Response to Reviewer 1

Response to Reviewer 2

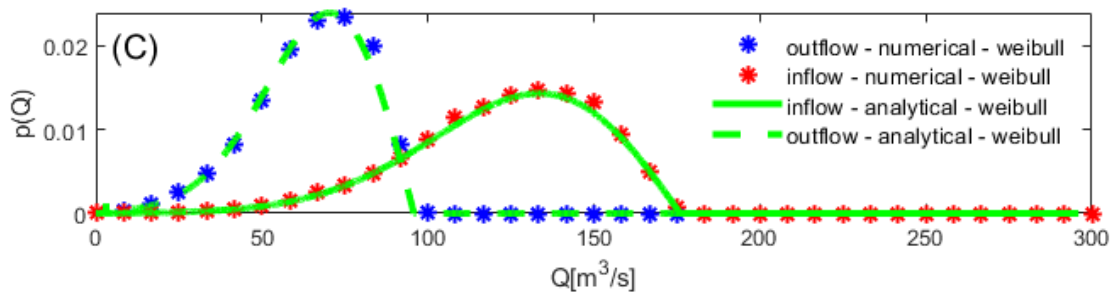
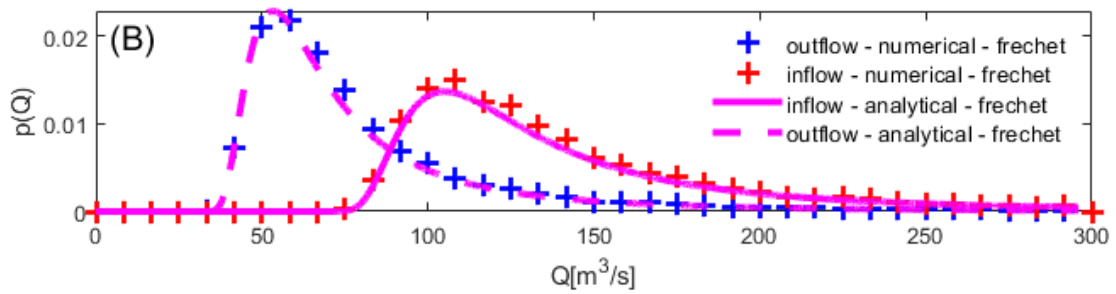
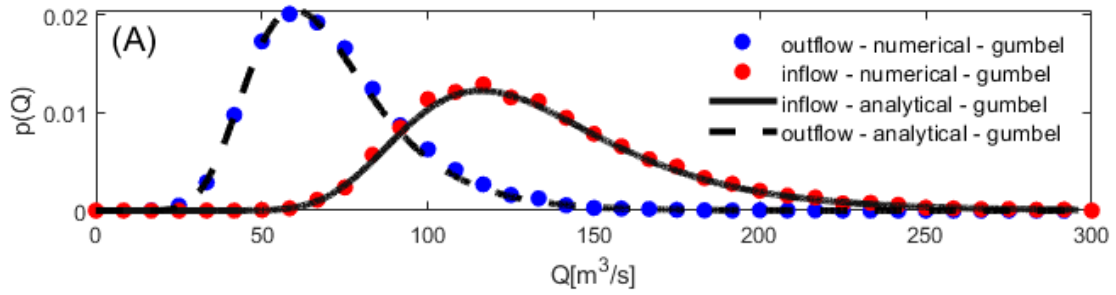
RC: Finally, I believe the readers would be very curious to see how the results would be modified if a heavy-tailed distribution was used instead of the Gumbel which has exponential tail. The exponential tails offer “no surprises” in the generation of random discharge values and thus the good results shown might be case specific and only for the Gumbel distribution. What would be the performance if really heavy tailed distributions were used, e.g., a GEV with shape parameter close to 0.5?

AC: In order to satisfy readers' curiosity, we provide in the following few examples where the peak outflow distributions are derived using flood peaks distributed according to the three types of GEV distributions (Gumbel, Fréchet and Weibull). Reliability of the derived distribution has been tested using a numerical simulation, which demonstrates the good agreement with the theoretical functions.
